CITY OF MADISON

PLAN OF PROPOSED IMPROVEMENT

8421 MANSION HILL AVENUE

REVISION 1 - 07/07/2025
-UPDATED SHEETS: P2, U2, L2, X2

15676	MADISON, WI	9649	CONTRACT NO:
PLAN & PROFILE - MICA ROAD			
8421 MANSION HILL AVENUE			
M:\DESIGN\Projects\15676\CAD\Streets\15676EN-PnP.dwg			
CITY OF MADISON WISCONSIN			
15676			
P-2

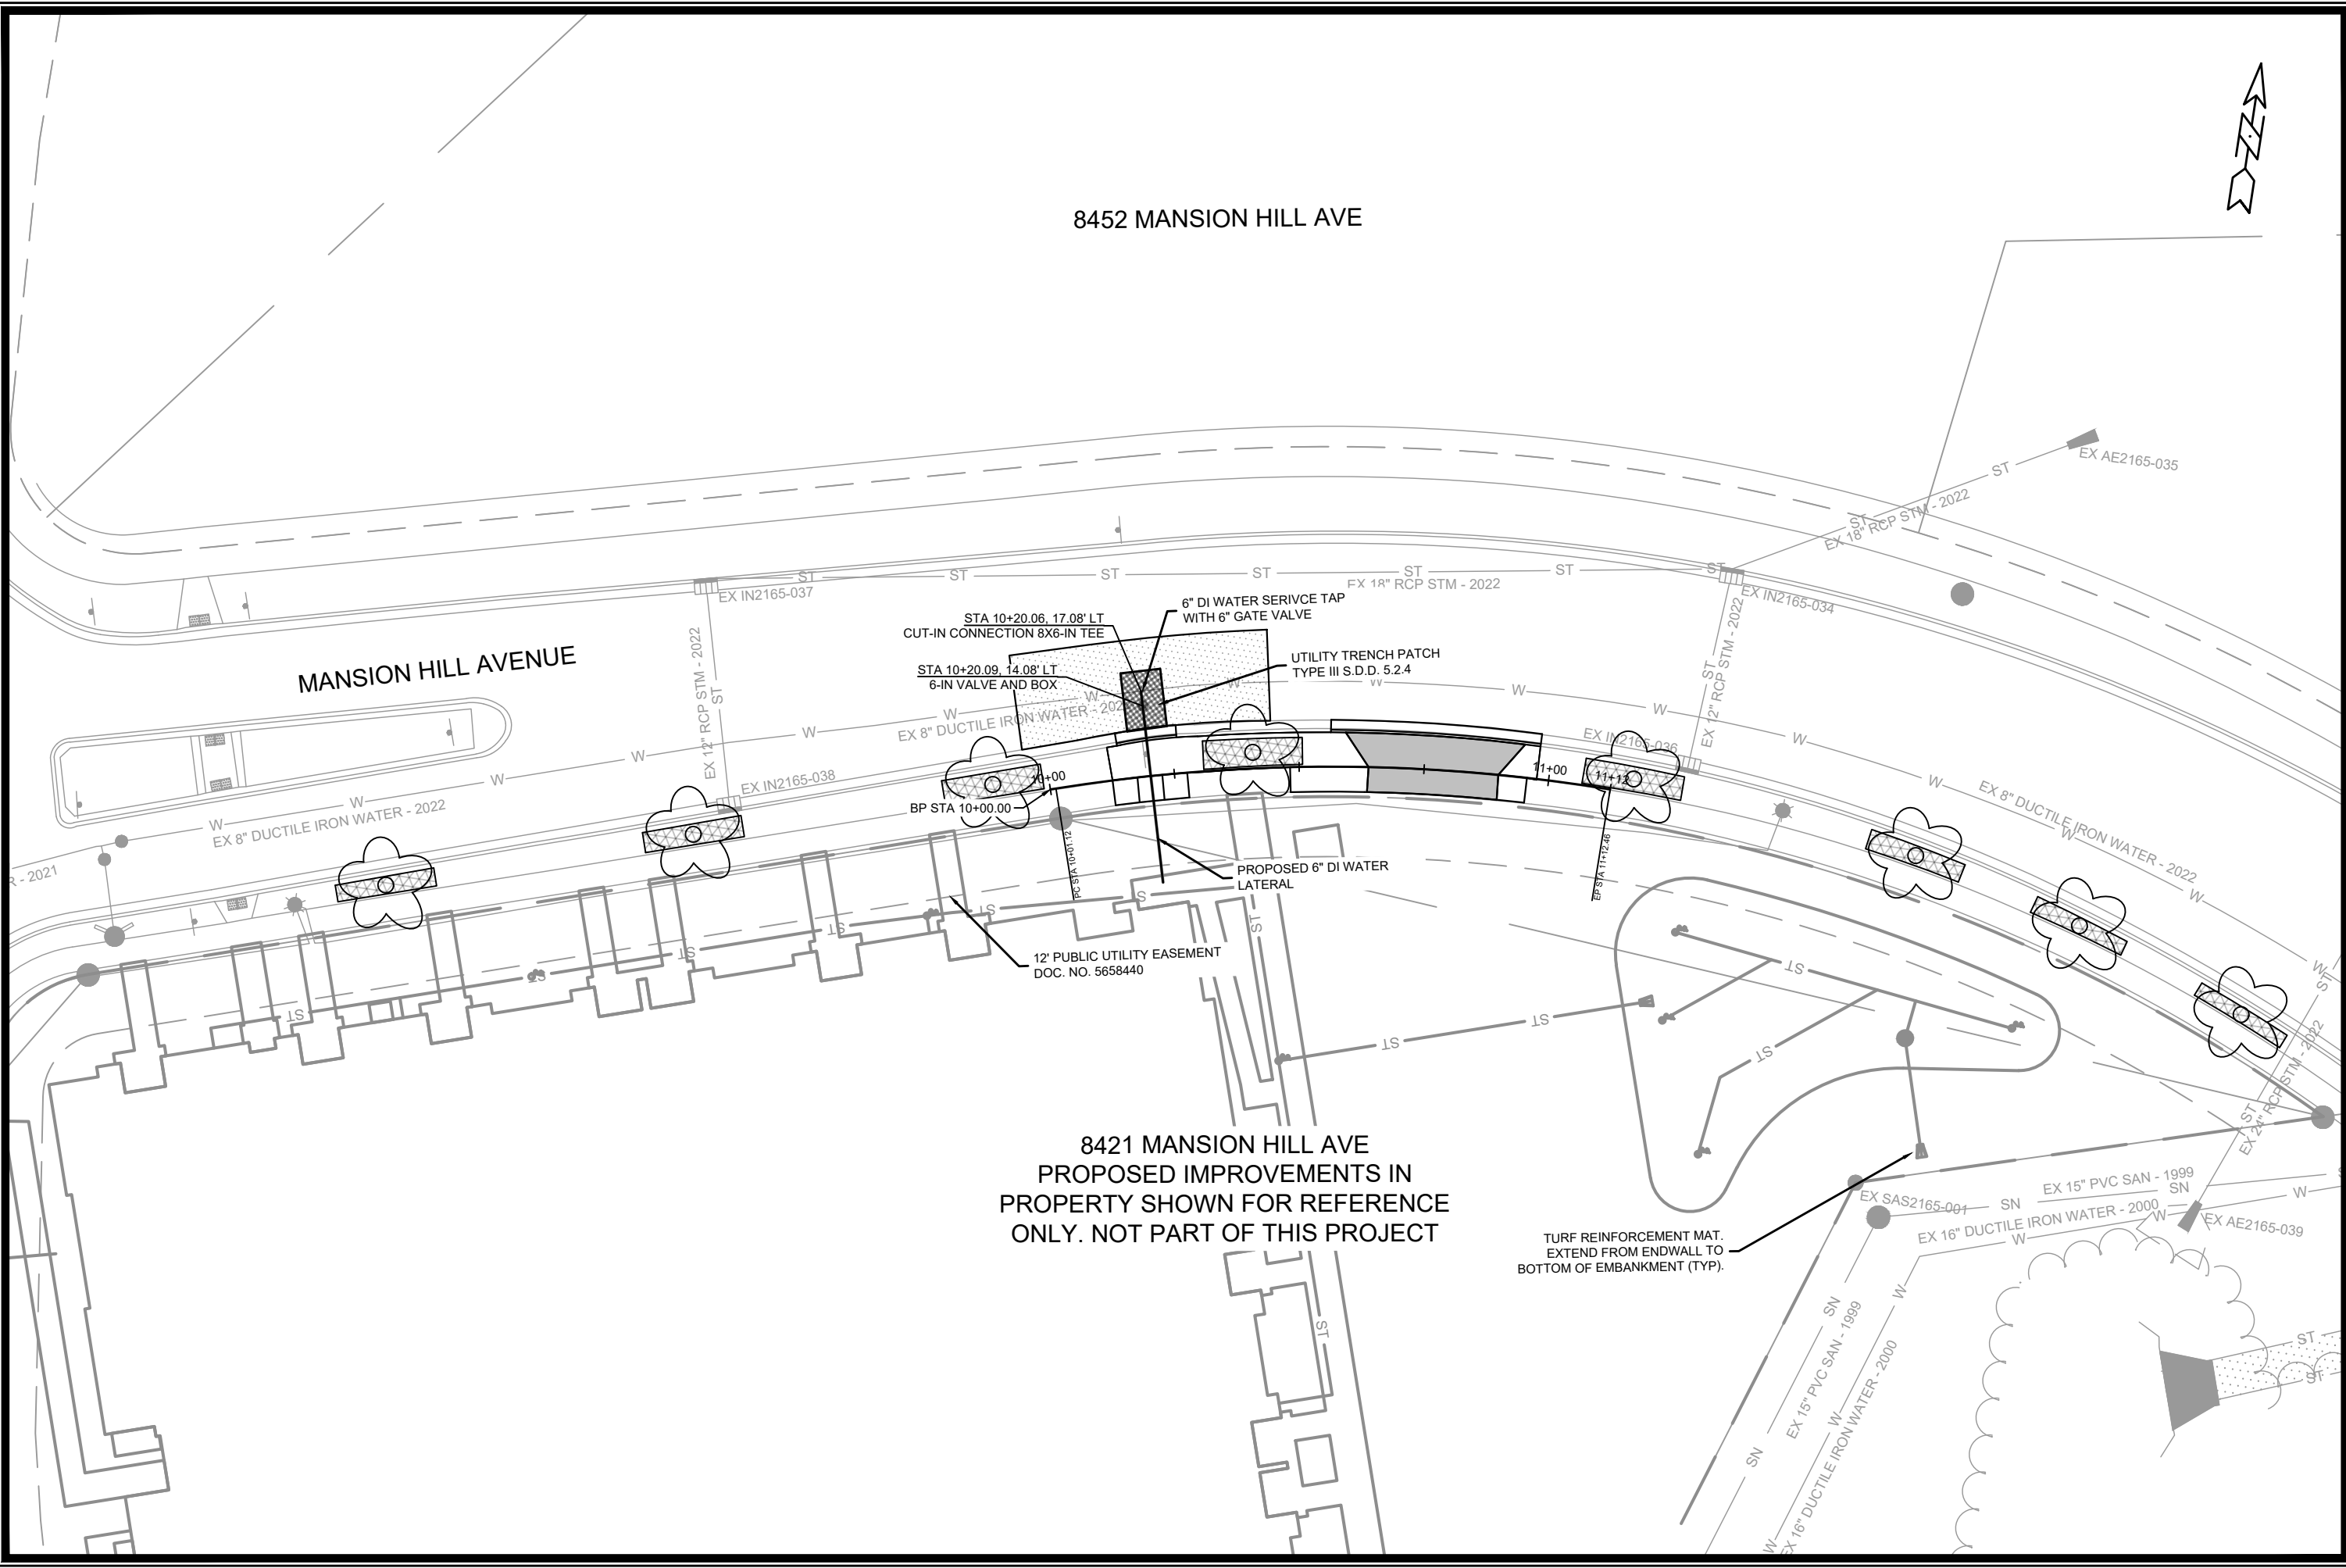
REVISION 1 - 07/07/2025
-UPDATED ASPHALT PAVEMENT
AND SIDEWALK LIMITS
-UPADTED F.W. PROFILE

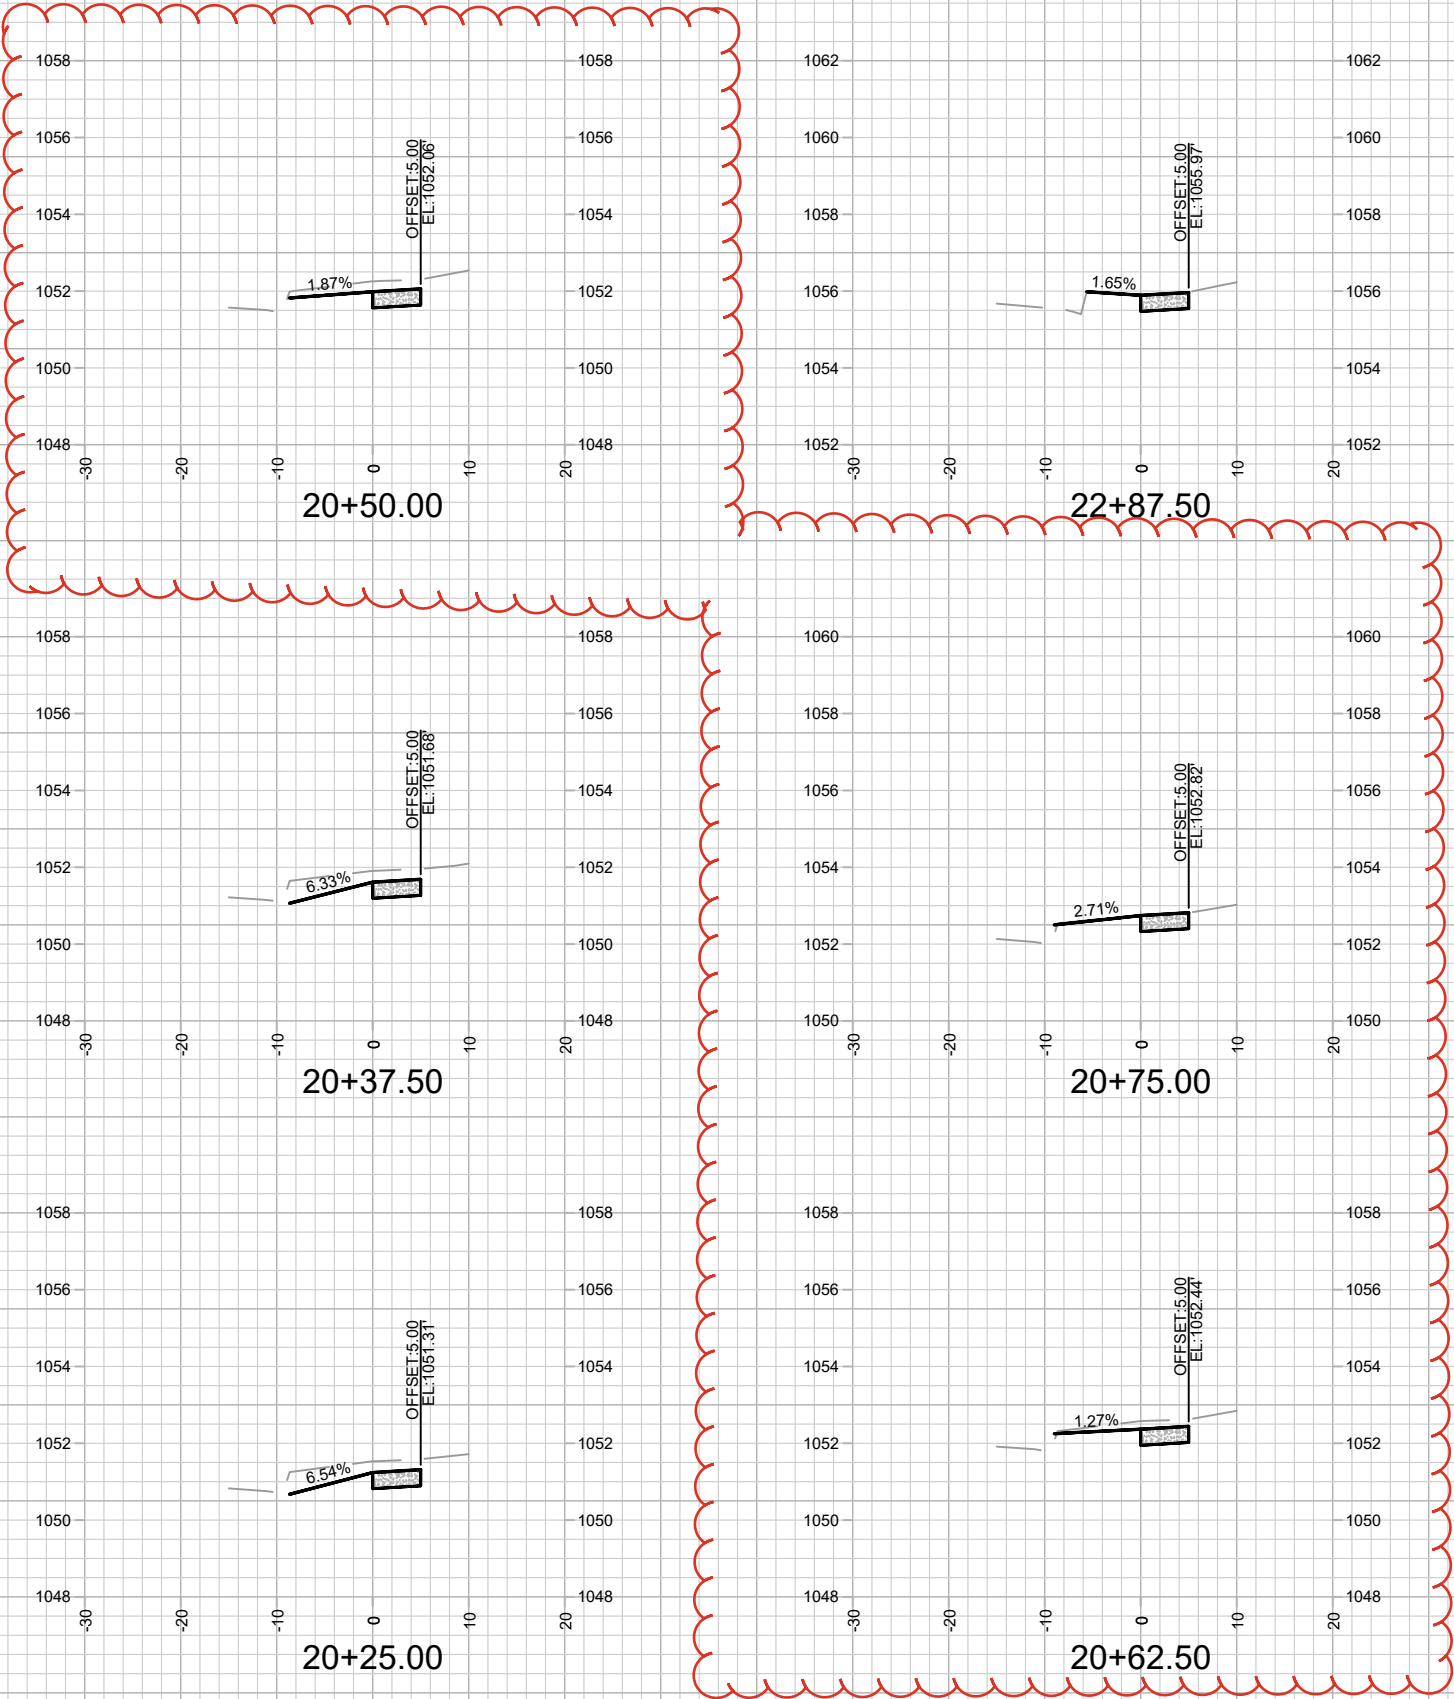
REVISION 1 - 07/07/2025
-UPDATED SIDEWALK LIMITS
GRADES
